**Re: Appeal of ARCOM Approval of Pedestrian Gate
ARC -24-0027 - Darlene & Gerald Jordan (“Applicants”)
Property Address: 203 S. Lake Trail (“Property”)**

Exhibit A

SITE PLAN
 203 S. LAKE TRAIL
 PALM BEACH, FLORIDA

PHOTOS OF EXISTING SITE CONDITIONS - SEABREEZE AVE

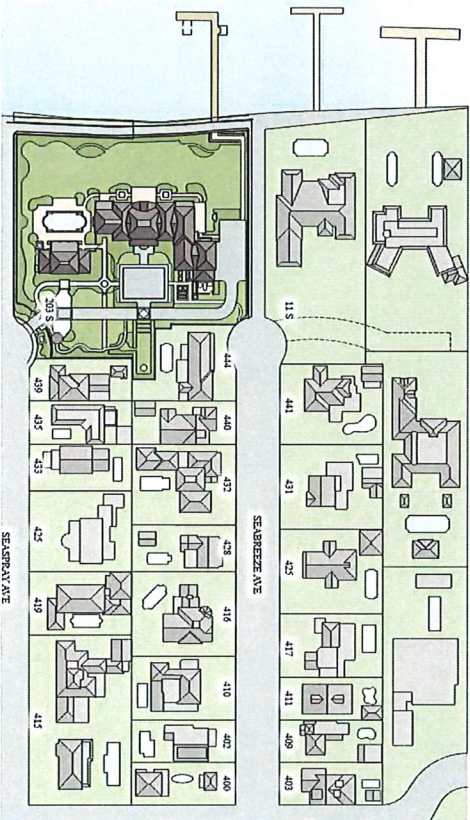
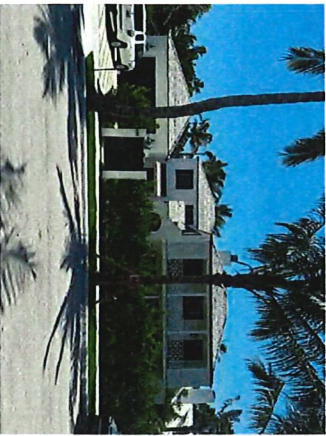
The Applicant is tasked with making sure that its Application is **complete and contains all the information** required for ARCOM to make an informed decision **prior to presentation**. Here it failed to do so. Instead, the Applicant omitted significant information within its Plans, namely the existence and location of a western driveway on the Wyrzes’ property the exit of which would clearly interact with the pedestrian gate. Given its existence, the Applicant should have provided detailed information on the location, size, and length of the Wyrzes’ driveway as well as where it exited onto the cul-de-sac to ensure the pedestrian gate would not interfere with the driveway and there would be no safety or other issues but did not. Instead ARCOM and the public were left with vague drawings which ARCOM relied upon, but only showed the Wyrzes’ eastern driveway despite the long-term existence of their western driveway.

Even though many of the ARCOM Commissioners indicated at the time of ex-parte disclosures they had reviewed the plans and were “familiar with the neighborhood” in general they apparently were not familiar with 444 Seabreeze. A quick drive by the Wyrzes’ home would have clearly demonstrated the existence of two driveways. More importantly, the Applicant’s own Application demonstrates clearly in the pictures on page A-7 that the Wyrzes’ home has two driveways with the western one exiting close to the middle of the curve of the cul-de-sac where the pedestrian gate was to be placed. *See*, Exhibit A.

PROPOSED SITE PLAN RENDERING

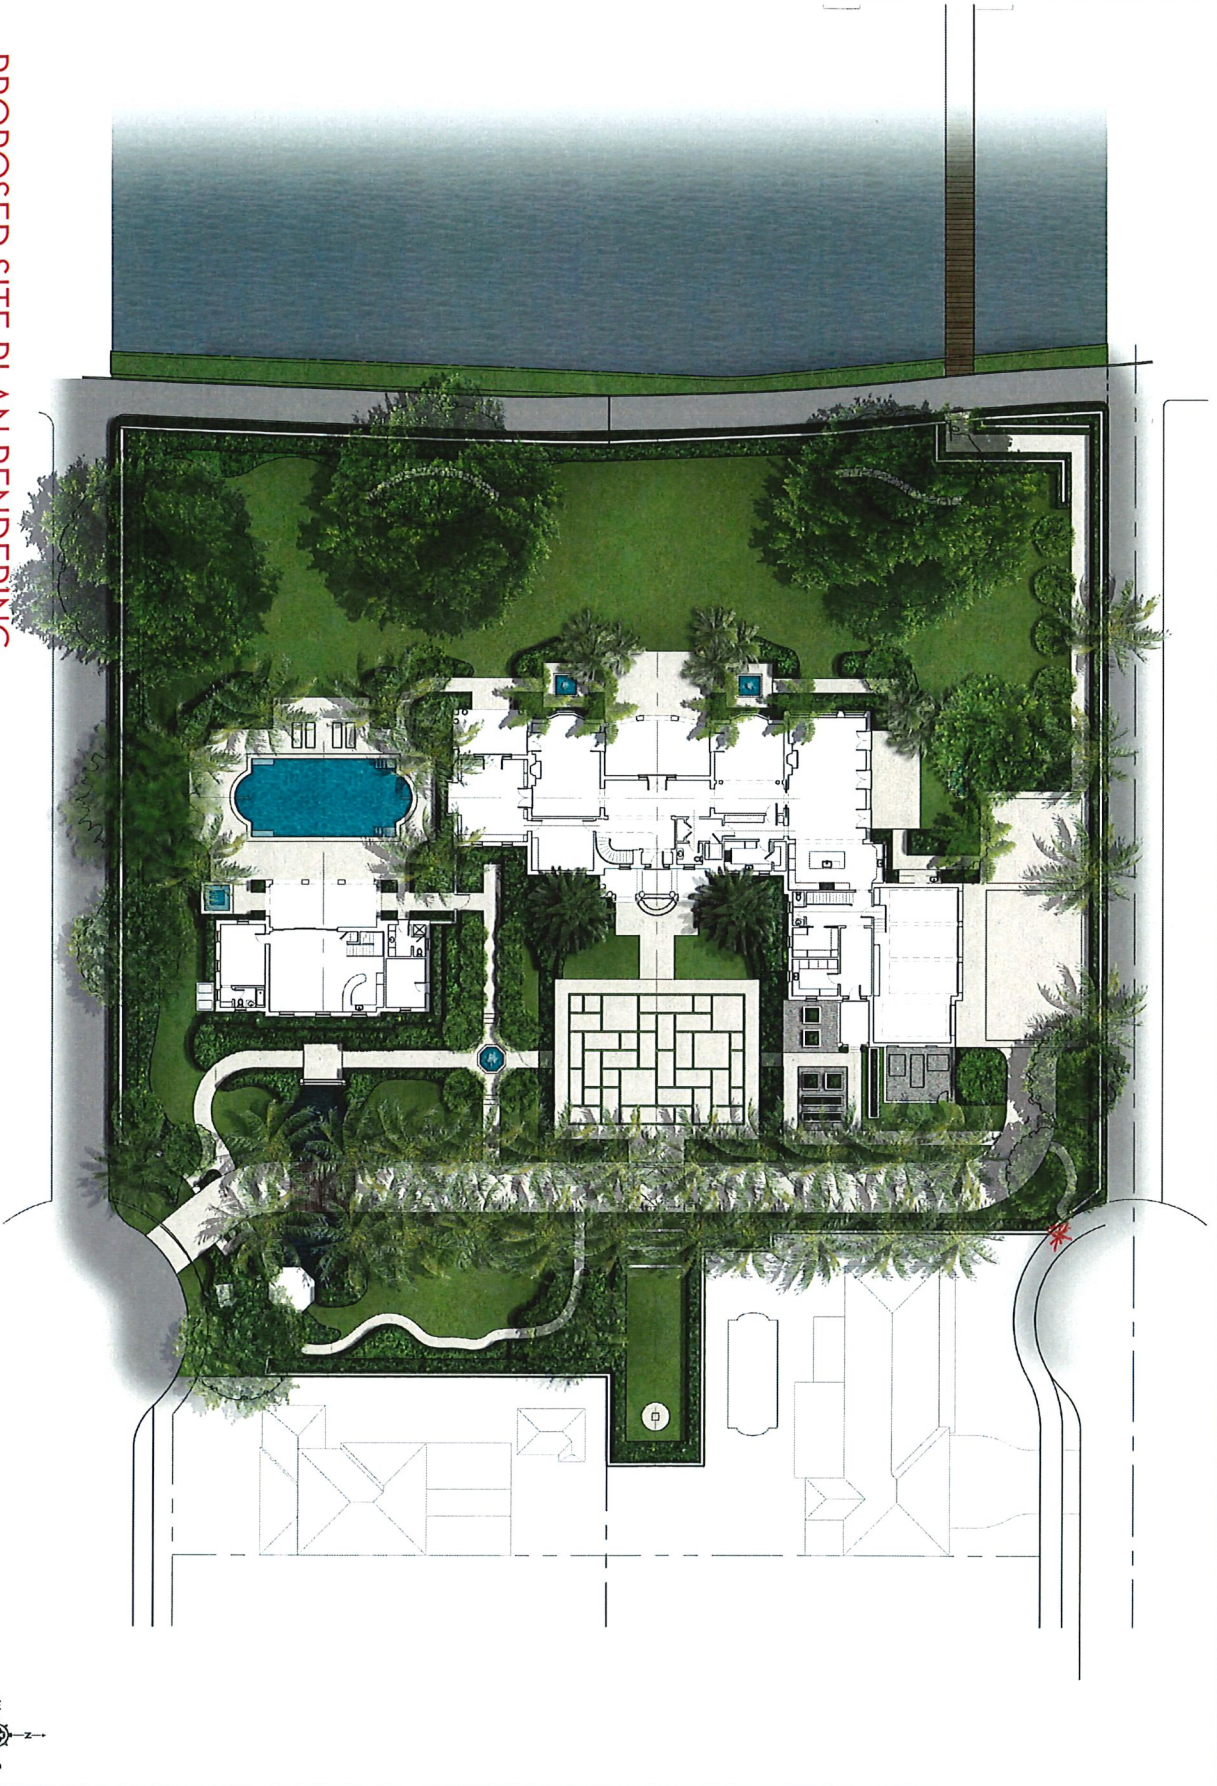
To make matters worse, ARCOM acted in reliance on the Applicant's incomplete information, while ignoring the testimony of Ms. Wyrzes, the only person with direct knowledge. In response to Mr. Nievera's pointing a cursor to the location of the gate (*See*, Exhibit B), Ms. Wyrzes indicated "So that's right by my driveway" which ends at the tip of the white area. Transcript, p. 41. Mr. Smith emphatically indicated "Your driveway is on the other side of your property. Your driveway is on the east side, and this is the west property." *See*, Transcript, p. 41-42 Ms. Wyrzes responded that she had two driveways, "Yeah, we have a driveway on the other side." "Yeah, on the west side." Transcript, p. 42. She further confirmed that it "was there when we moved in." *Id.* There was no testimony disputing the existence of the western driveway or its location, yet ARCOM treated the Wyrzes property as if it had only the eastern driveway.¹

Clearly the location of the pedestrian gate could radically change the Wyrzes use of their driveway as well as create a safety issue of having pedestrians cross directly behind a vehicle backing out of the western driveway or delivery trucks blocking the driveway thinking they could gain access to the Property from the pedestrian gate. Ms. Wyrzes testified that even without the gate she had to "chase an Amazon truck down the street yesterday because they were headed for the lake trail trying to make a delivery to the Jordans." Transcript, p. 40 "I'm worried that I'm going to have packages in my driveway being left at that gate, if there's another gate." Transcript, p. 40.

At that point, ARCOM should have deferred any further consideration of the pedestrian gate until such time as the Applicant came back with additional information on the exact location of the gate and whether it would or would not interfere with the use of Wyrzes' western driveway. In choosing to move forward and unanimously approving the gate anyway ARCOM acted without such crucial information. As such, its Approval was not based on competent substantial evidence and should be reversed.
